Illinois Department of Transportation

SUBJECT: Abraham Lincoln Capital Airport
Springfield, Illinois
Sangamon County
Illinois Project Number: SPI-4977
AIP Project Number: N/A
Contract No. CA024
Item No. 13A, January 19, 2024 Letting
Addendum A

NOTICE TO PROSPECTIVE BIDDERS

REMOVAL PLAN

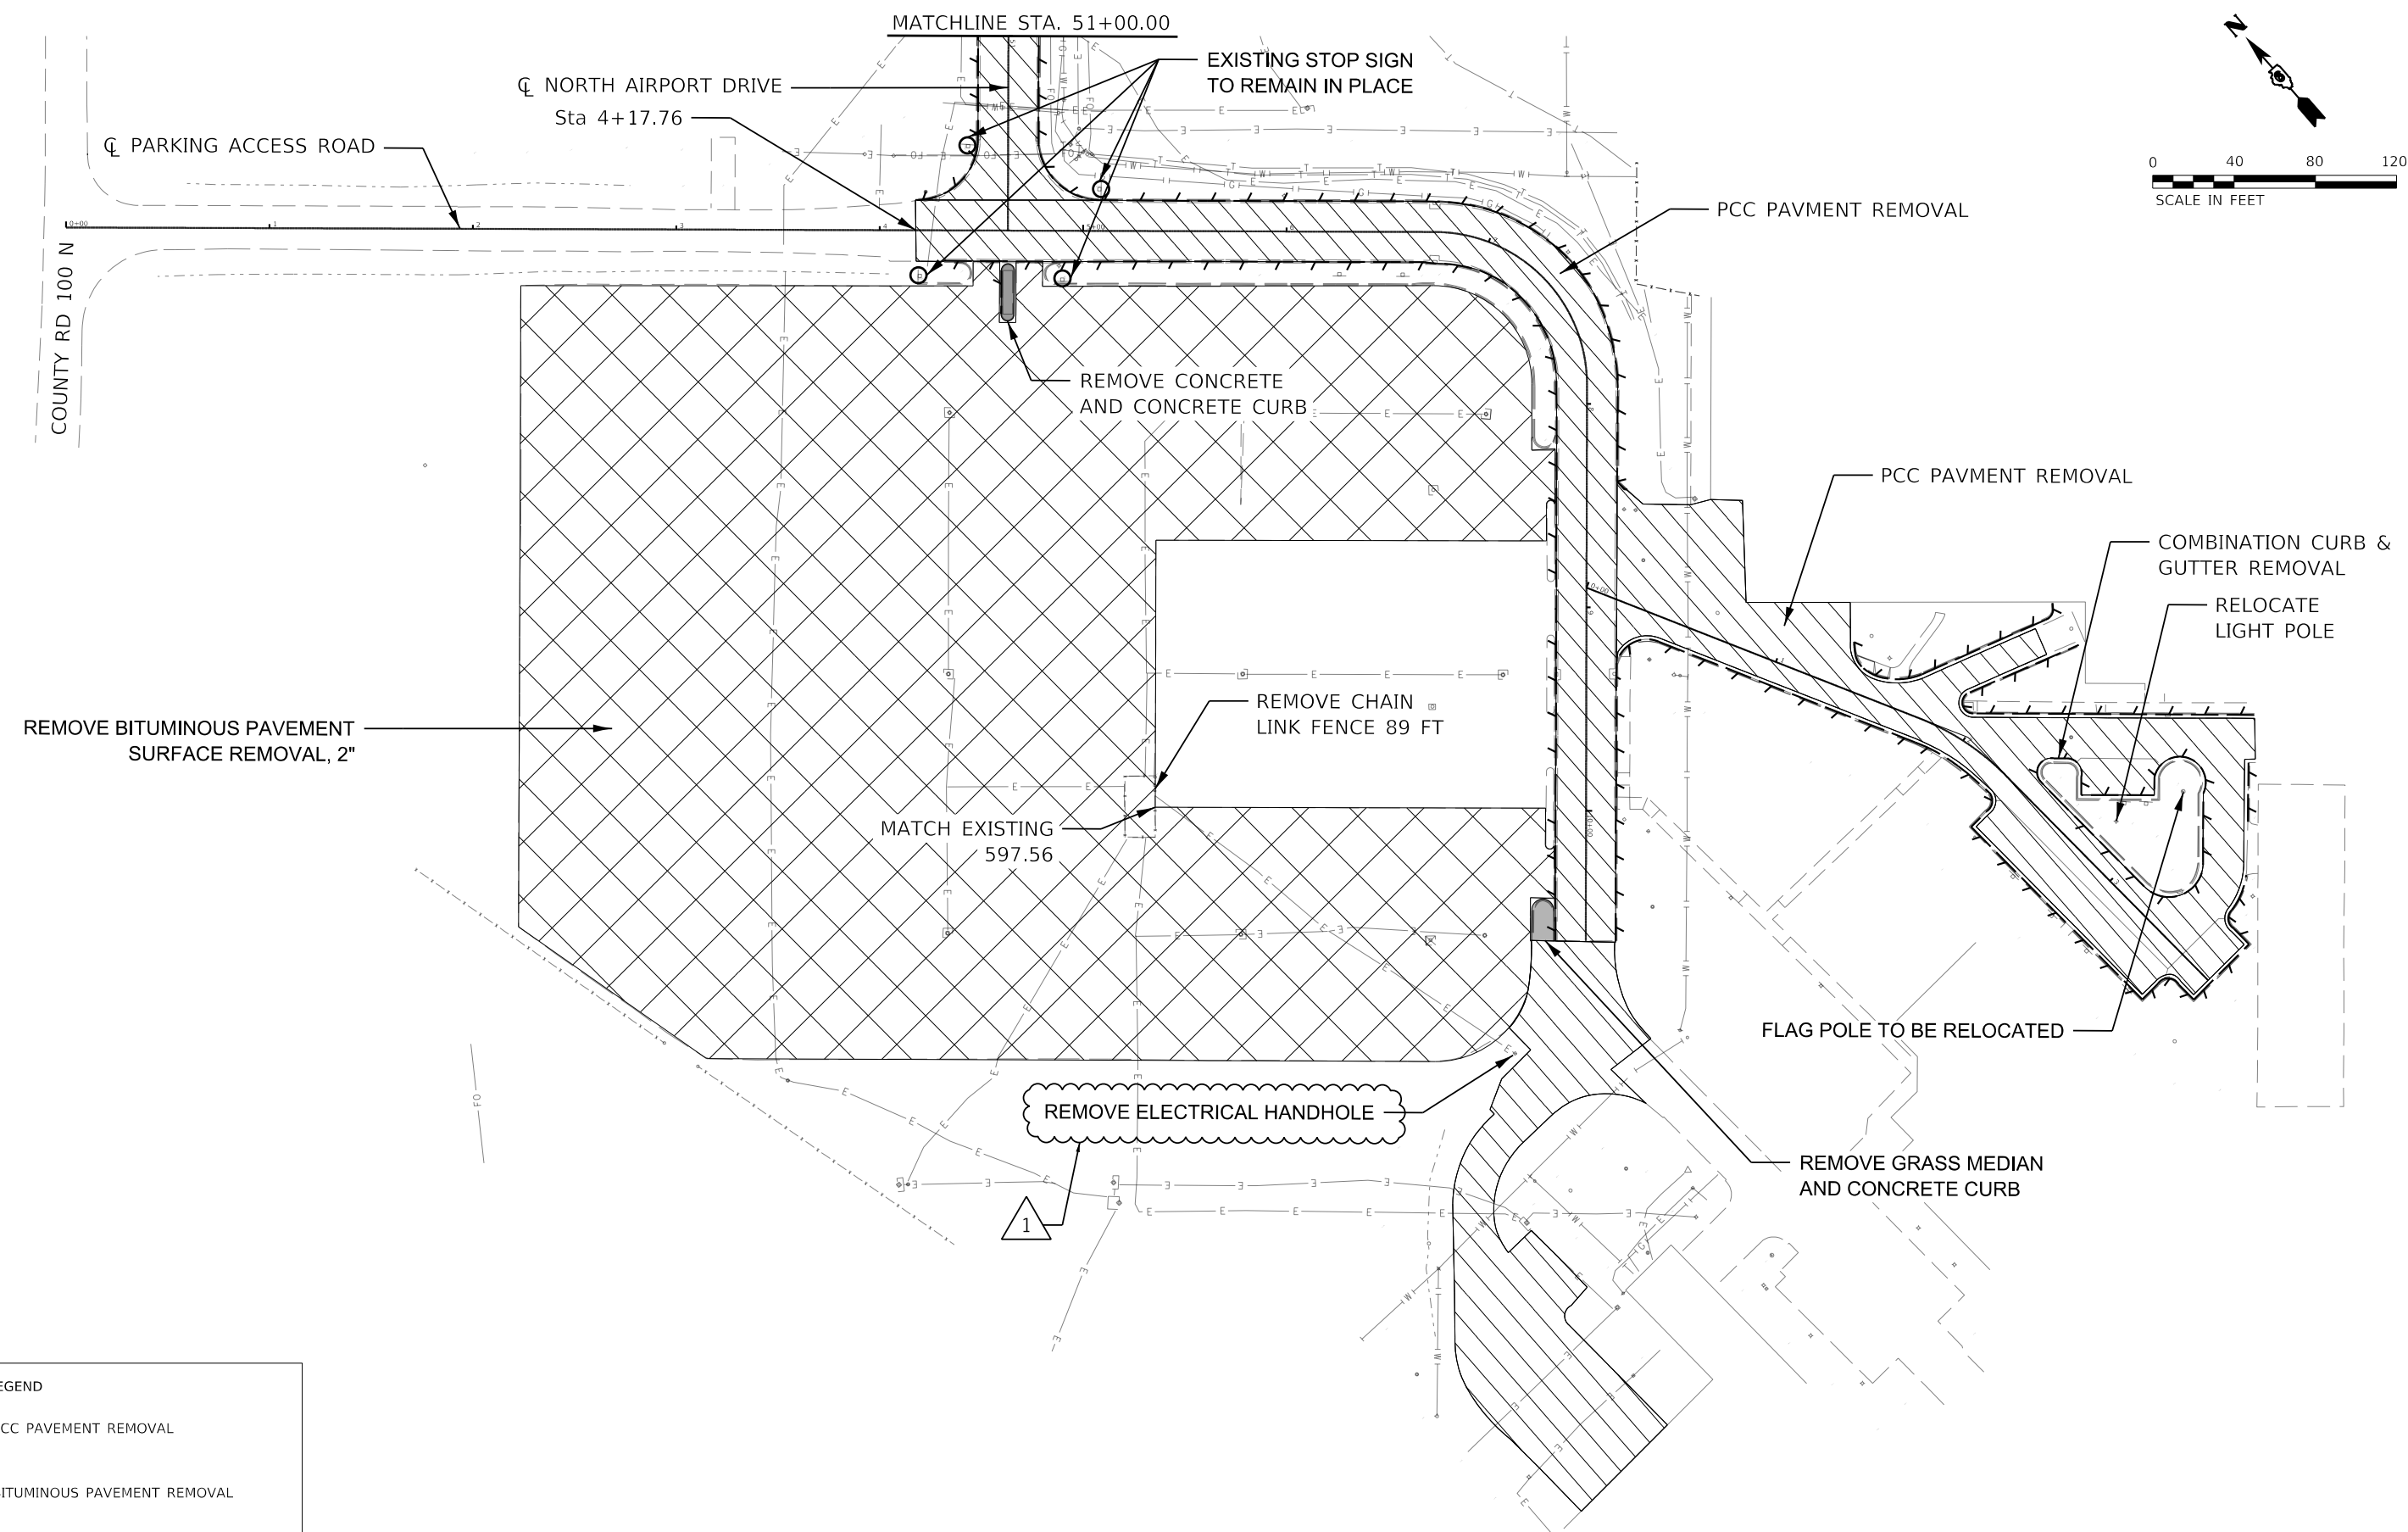
The pay items and quantities have been updated to reflect the current scope of work. Grading and paving in the main parking have been expanded to create a more useable layout.
